8568B-04A

S E R V I C E N O T E

HP 8567A Spectrum Analyzer
 HP 8568A Spectrum Analyzer
 HP 8568B Spectrum Analyzer

Frequency Spur Correction

Figure 1. Component Locations

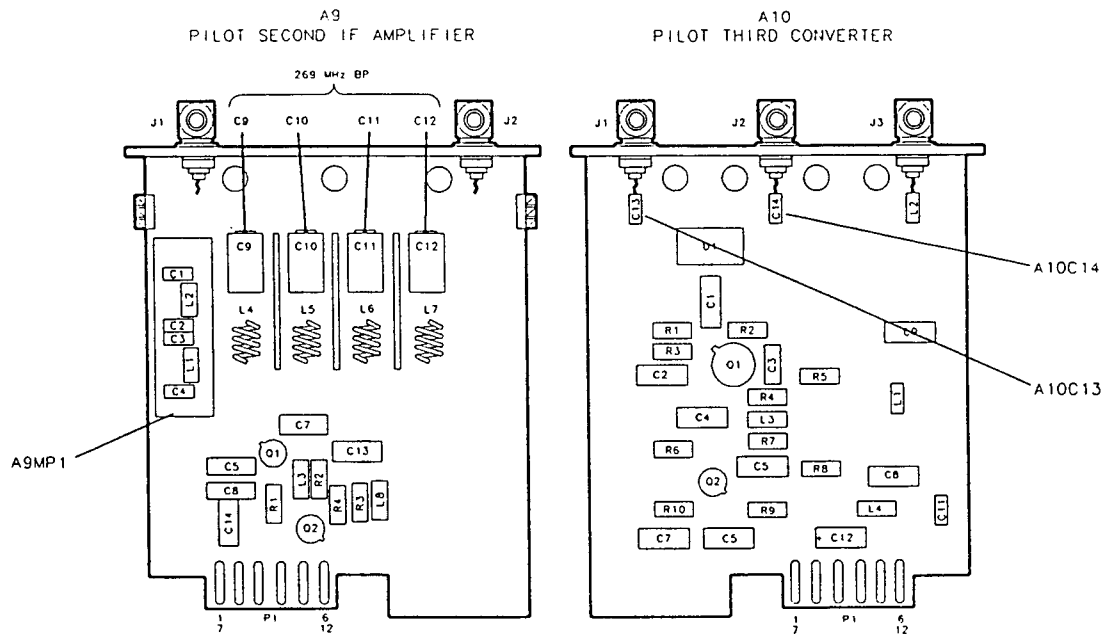
Signals from the A23 RF Converter Assembly feed through the A9 Pilot Second IF Amplifier Assembly and mix with the A10 Pilot Third Converter Assembly. This prevents the spectrum analyzer's meeting specifications for spurious responses (75 dB below -40 dBm total signal power at the input mixer).

1. Separate the two instrument sections and set the IF-Display section aside.
2. Remove the two rear feet and the bottom cover from the RF section.
3. Using a #1 pozidrive screwdriver, remove the 4-40 screws from around the A9 Pilot Second IF Amplifier and the A10 Pilot Third Converter Assemblies. Remove these assemblies from the instrument and place them on a static-free work surface.
4. Solder A9MP1 (HP part number 7100-1304) to the ground plane as shown in Figure 1.

The shield is installed over the A9 lowpass filter. First remove the upright shield between this filter and A9C9 and A9L4, if present.

5. Install the two 10 pF capacitors on the A10 assembly. See Figure 2.
 - a. Solder one lead of A10C13 to A10J1 and the other lead to the ground plane.
 - b. Solder one lead of A10C14 to A10J2 and the other lead to the ground plane.
6. Install the A9 and A10 assemblies into the RF section.
